To: San Mateo County Planning Commission

Re: Oct 26 meeting, agenda item 5.

Tunitas Creek Beach County Park Improvements.

County File Number: PLN2021-00485

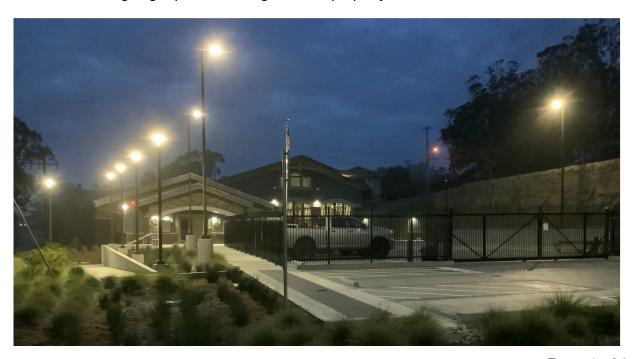
Throughout the report, there are references to sensitivity to surrounding areas and confining the light to the area needed, such as in this example, addressing concerns in Attachment G:

All lighting, exterior and interior, must be placed, designed and shielded so as to confine direct rays to the parcel where the lighting is located.

However, there are no lighting plans presented and no controls established on how the lighting actually gets implemented.

I request that, as a condition of approval, you impose:

- 1. A detailed lighting plan.
- 2. Some sort of direct compliance checks on the lighting for this project. One suggestion would to request a set of luminance measurements at specific distances from the light source, e.g., 50 ft., and maybe from points along the beach, to show that no light is escaping the intended lighted area.
